KINGSTATE ELECTRONICS CORPORATION

PRODUCT CHANGE NOTICE:

We hereby announce that the part no.: KSSG13J12-N has been executed with a change. The updated product will be: KSSG13J12-N

VERSION: TKS-5013-1.6

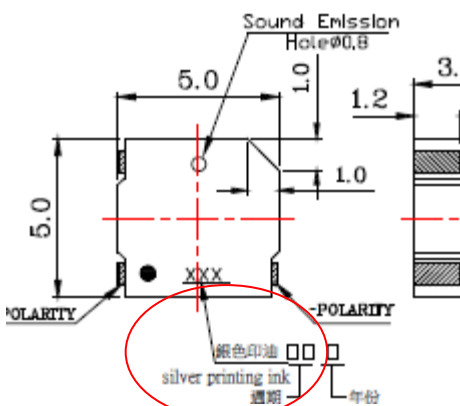
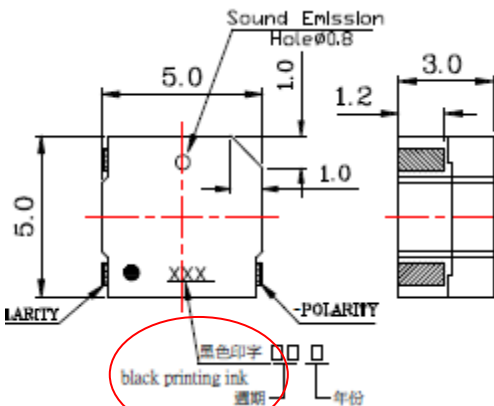
Change	Before	After
改變地方 Due to environmental protection requirements and health and safety concerns, the original manual silver printing will be replaced with automatic and black ink printing.因環保要求及健康安全原因: 原人工銀色印字變更黑色自動噴墨印字	變更前 (附圖紙)  成品(附圖) 	變更後(附圖紙)  成品(附圖) 
	Remark: No change size and other characteristics of the product 產品的其他尺寸及特性無變更
